3.6 Individual Comments and Responses

**2012 Central Valley Flood Protection Plan
Final Program Environmental Impact Report**

Figure E-7. MSAC3 Conceptual Setback Area, Sacramento River

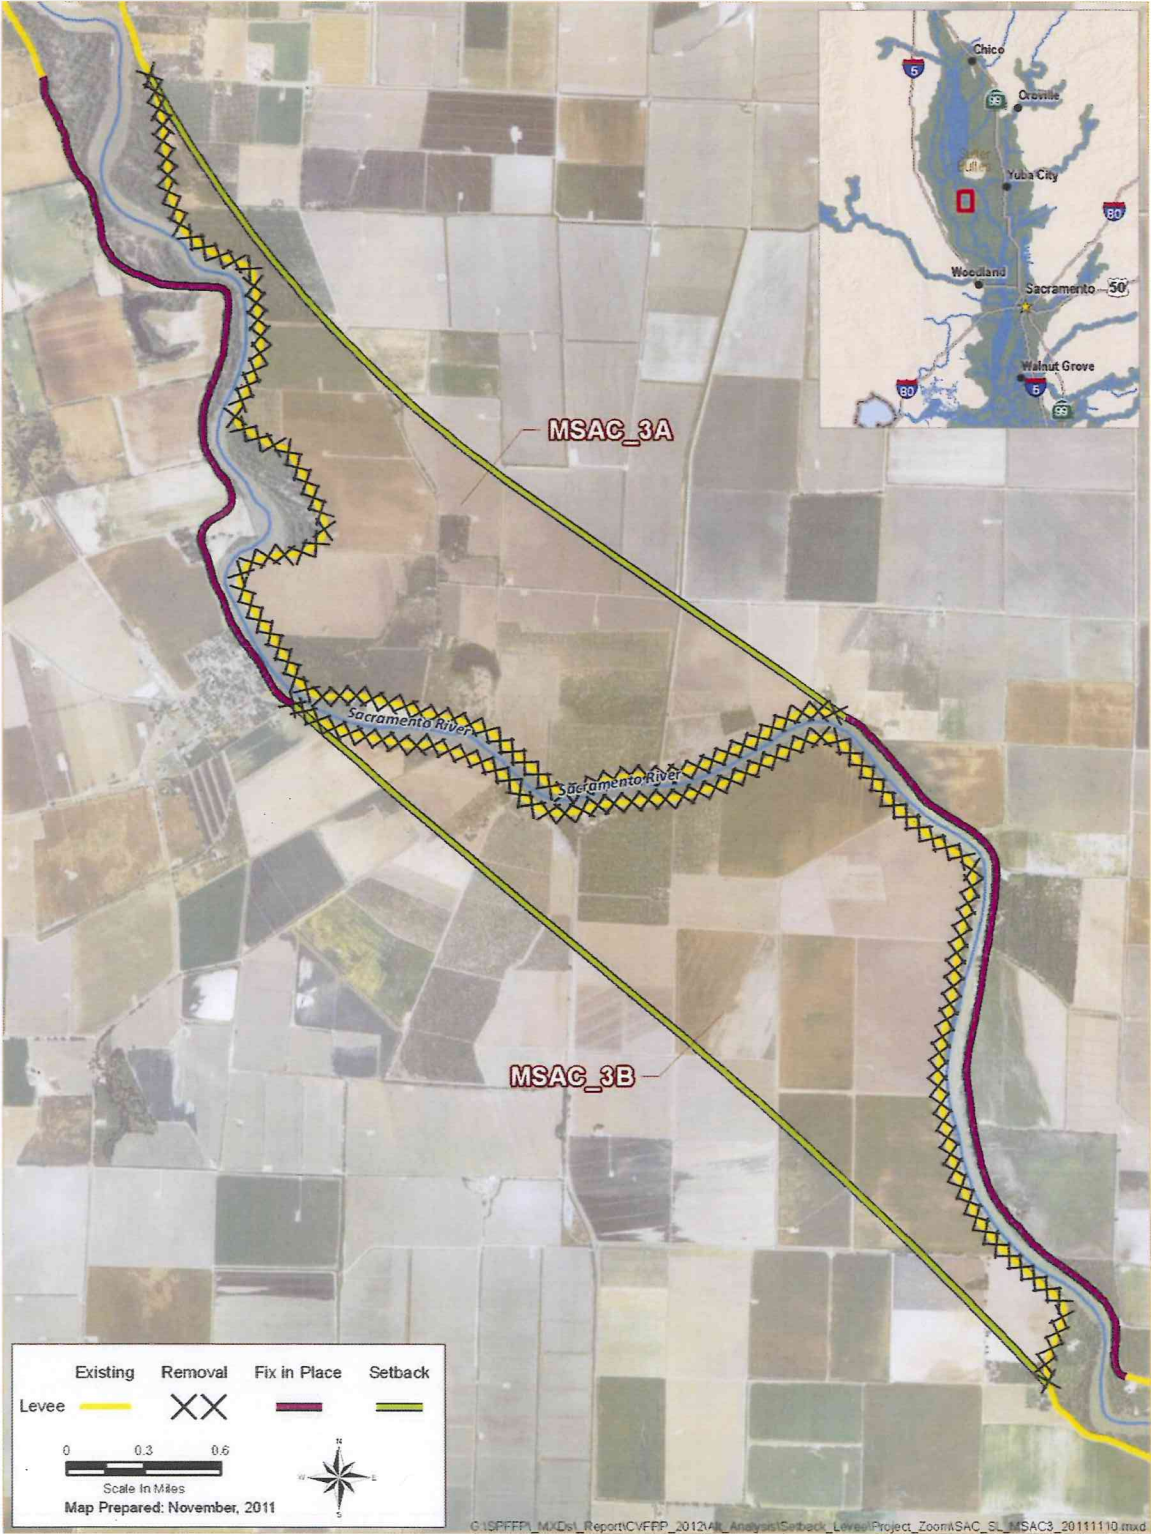
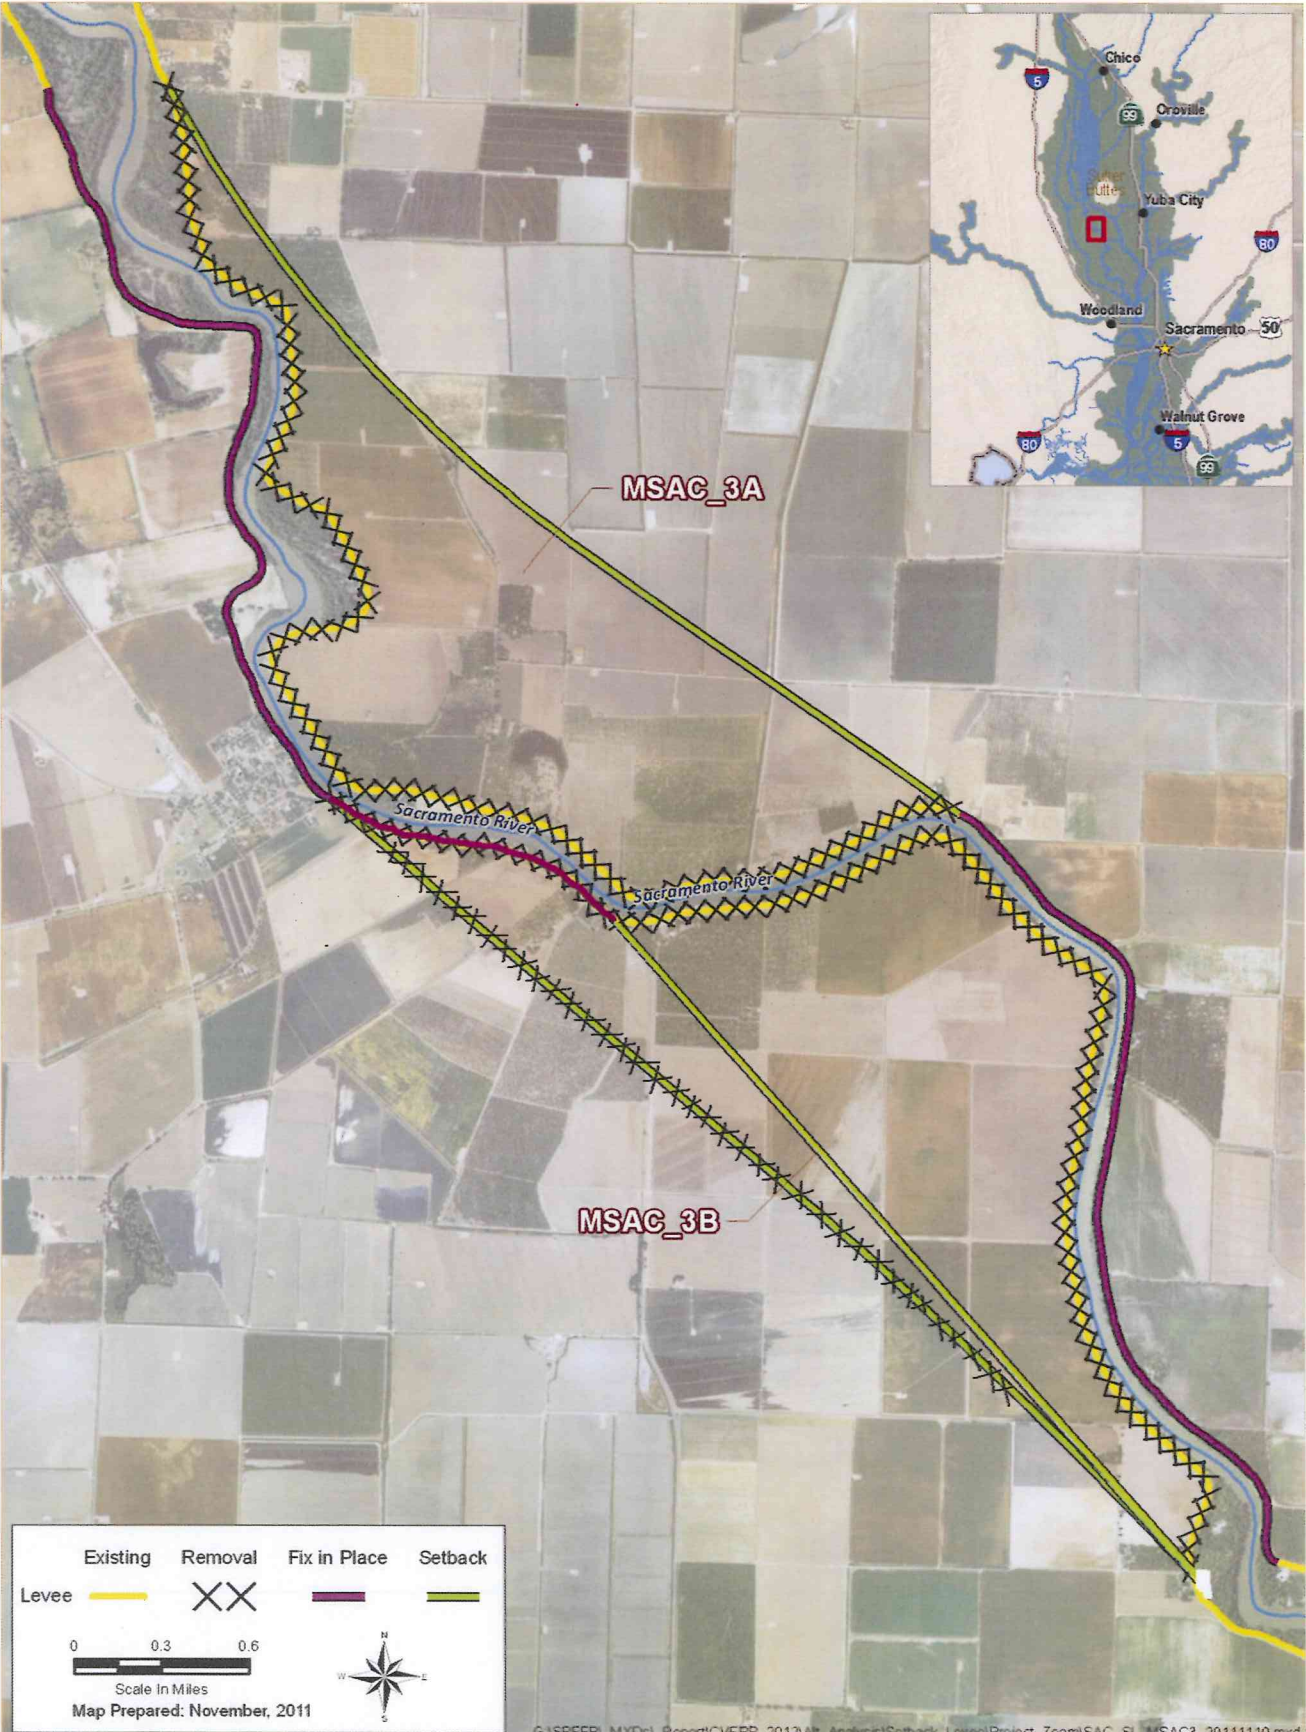
Currently, the plan proposed to reinforce the levee adjacent to the community of Grimes but then recommends building a setback levee beginning on the southside of town and removing the existing levee (see attached Figure E-14 and related discussion). This will result in the loss of several acres of farm land as well as the historically significant home and the Moore brothers' marina. Rather than produce income for our family, feed people around the world, and provide access to the River for local residents, these lands will revert to riparian habitat. This will be a large loss to the town of Grimes and a devastating loss to the Moore family.

As such, we humbly request that the Board modify the draft plan with respect to a setback levee south of Grimes (including but not limited to Figure E-7, attached, and the discussion on page D-50) to remove the proposed setback levee on the west side of the River and instead "fix in place" the existing levee south of Grimes. This alternative will provide protection from a one percent AEP flood for the broad community of Grimes, including its industry, historic places, and amenities. In the alternative, if a setback levee is necessary to meet the goals of the CVFPP, we request that its alignment be modified as shown on Exhibit A (attached). This alternative alignment will reduce impacts to agriculture while avoiding the historic Moore Family home and the only marina.

The comment references conceptual levee setback element depicted on a map shown as Figure E-7, page E-14 map in DPEIR Appendix A, “Central Valley Flood Protection Plan,” Attachment 8J. As stated in Master Response 20, this particular conceptual setback was developed primarily for cost evaluation and comparison purposes. Specifically, Tables 6-11 and 6-15 in Attachment 8J, “Cost Estimates,” found in Volume IV of DPEIR Appendix A, “Central Valley Flood Protection Plan,” summarize the cost items assumed for the Enhance Flood System Capacity approach and for the SSIA, respectively. The cost of any rural setback levees (including the conceptual setback of concern to the commenters) is reflected in Column 15, “Rural Setback Levees,” of each table. When comparing these two tables (regarding the SSIA and Enhance Flood System Capacity approach, respectively), the costs of conceptual rural setback levees were included in the Enhance Flood System Capacity approach (Table 6-11), but the corresponding value in Table 6-15 is zero, further confirming that the conceptual levee of concern to the commenters is not included in the recommended SSIA.
